**FURTHER INFORMATION RECEIVED
ON THE 18TH OF DECEMBER 2024**

Lizard Management Plan for 87 Upper Sefton Road, Ashley, Canterbury

Contract Report No. 7300b

McCracken and Associates (MCA) has requested Davis Ogilvie & Partners (DO) to respond to the request for information (RFI) received from Waimakariri District Council dated 7 December 2023, in regard to the Energy Bay Limited resource consent (RC235259) for a proposed solar farm. We had addressed RFI items 5 (stormwater) and 14 (firefighting and water supply) in an earlier revision of this letter memo dated 3 July 2024. We enclose further information in response to the RFI and subsequent questions.

CROSS SECTION 87 UPPER SEFTON ROAD CULVERT

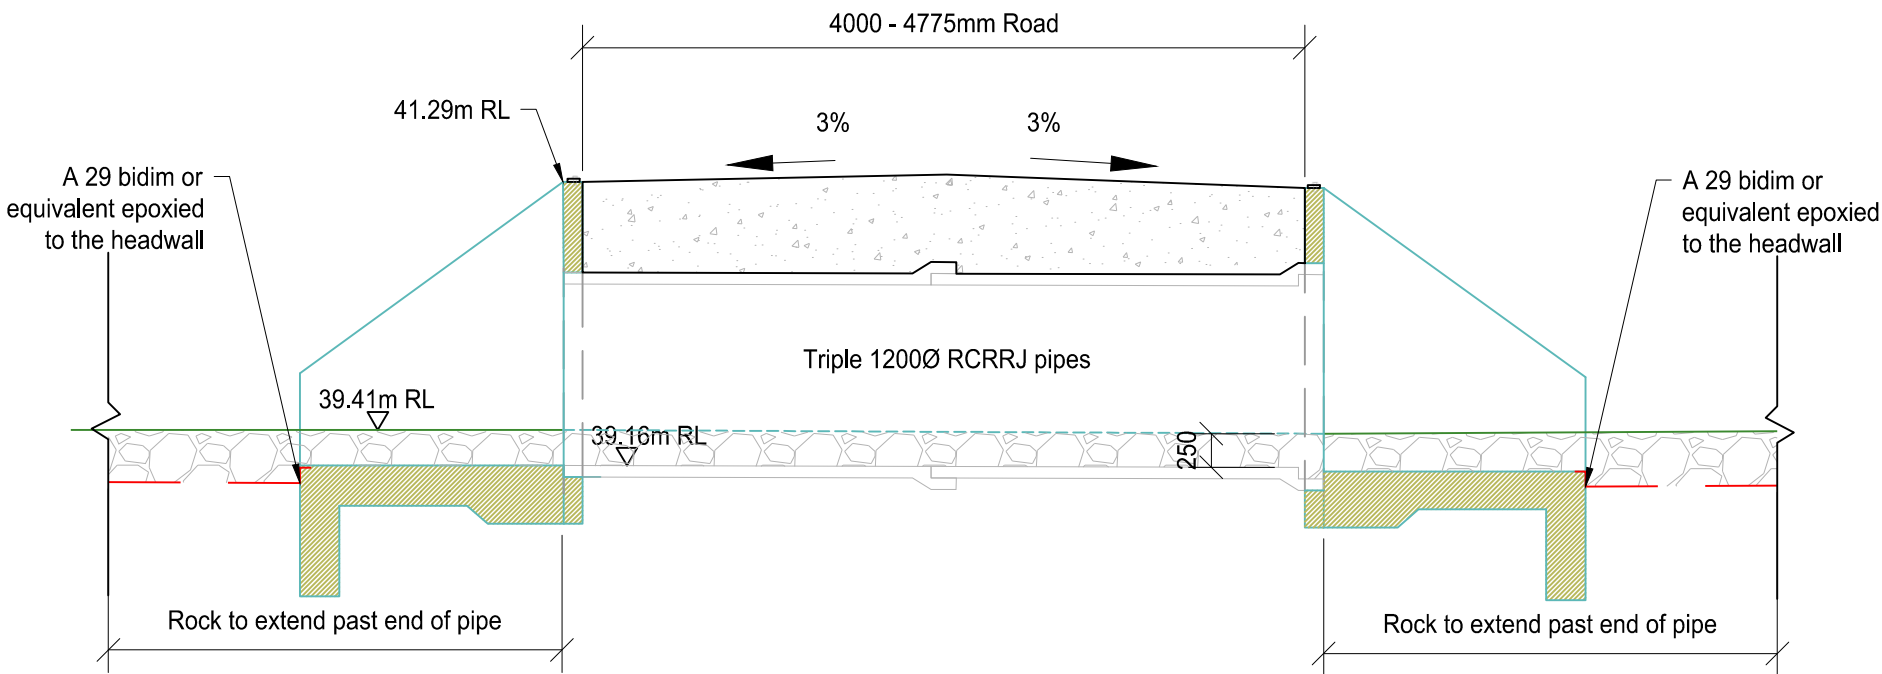
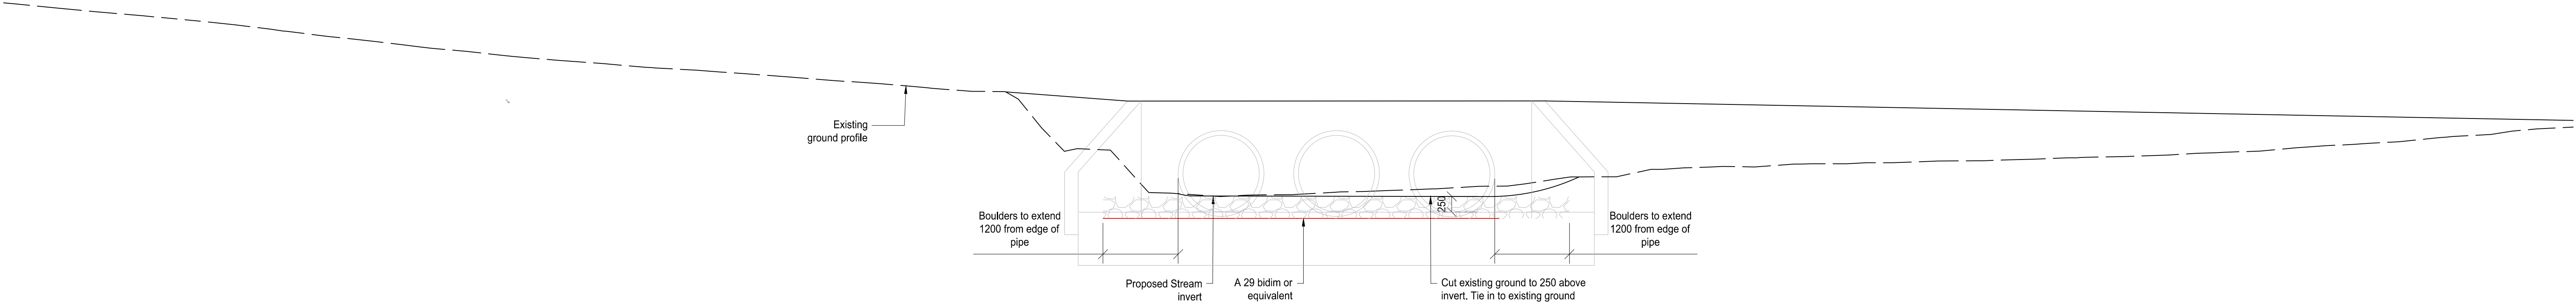
1. *The consent holder shall install an access culvert across the Site drain at the approximate coordinates 5209870mN 1568561mE as shown on the approved plan (XXXX). The culvert shall pass a minimum flow derived from a 20-year ARI rainfall event to RCP 8.5, year 2081 to 2100.*
